ARKANSAS NUCLEAR ONE, UNIT NO. 1

AMENDMENT TO FACILITY OPERATING LICENSE

Amendment No. 49  
License No. DPR-51

SAFETY EVALUATION BY THE OFFICE OF NUCLEAR REACTOR REGULATION

ARKANSAS POWER & LIGHT CO. ARKANSAS NUCLEAR ONE-UNIT 1	PROTECTIVE SYSTEM MAXIMUM ALLOWABLE SET POINT	FIG. NO. 2.3-1
-----------------------------------------------------------	--------------------------------------------------	-------------------

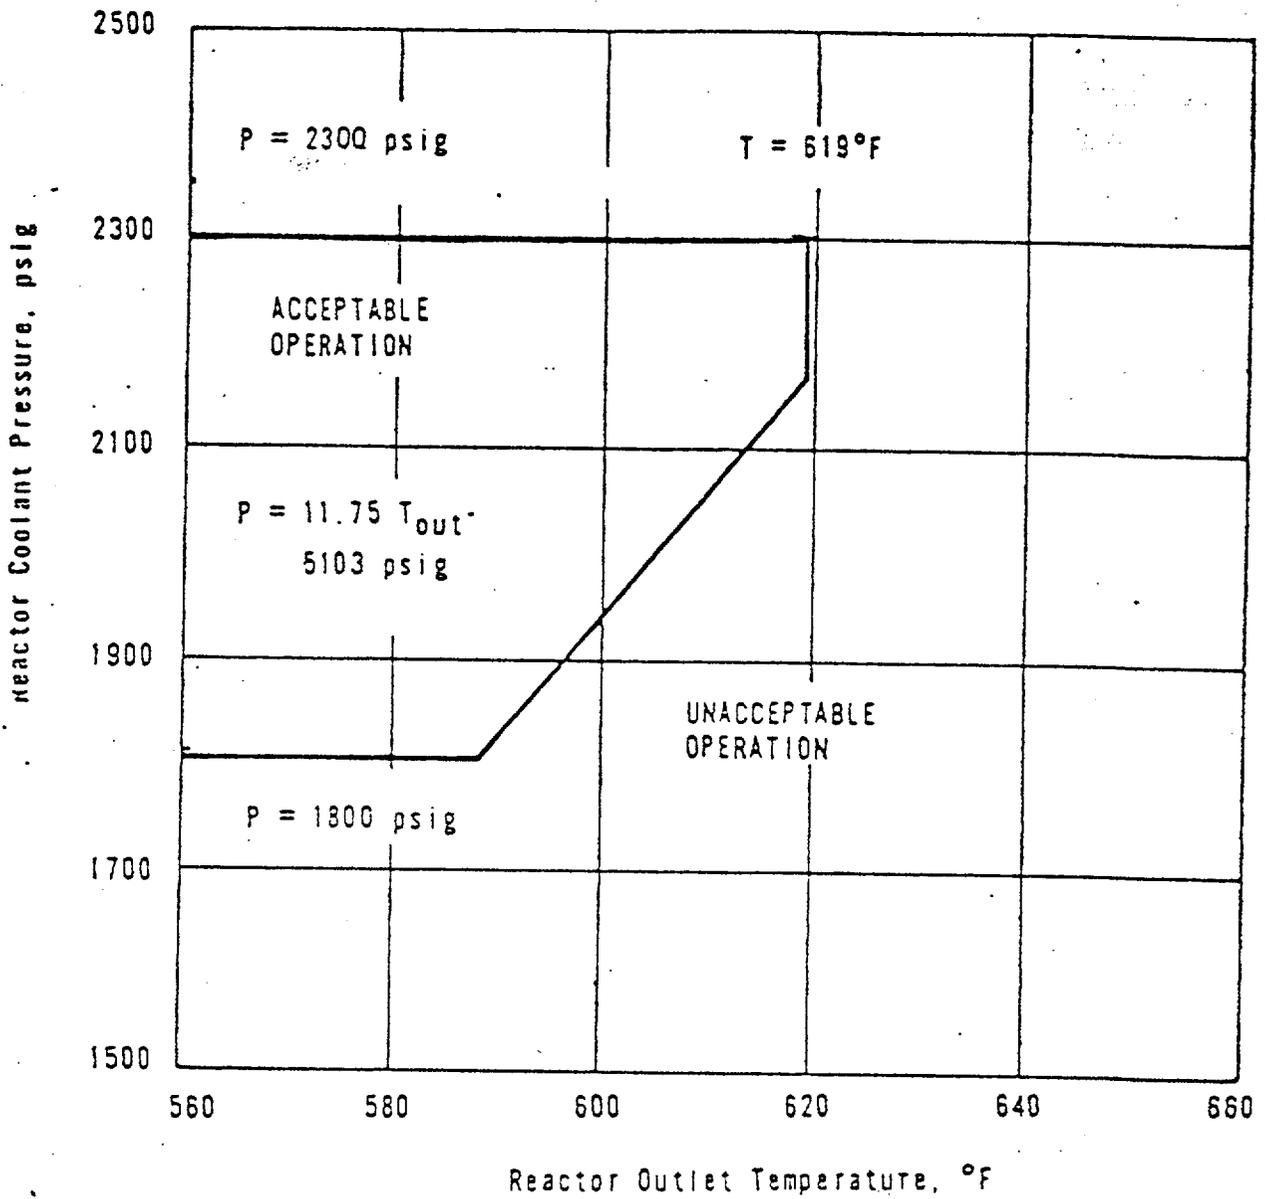
shown in Figure 2.3-1 for high reactor coolant system pressure (2300 psig) has been established to maintain the system pressure below the safety limit (2750 psig) for any design transient. (2) The low pressure (1800 psig) and variable low pressure (11.75T<sub>out</sub>-5103) trip setpoint shown in Figure 2.3-1 have been established to maintain the DNB ratio greater than or equal to 1.3 for those design accidents that result in a pressure reduction. (2,3)
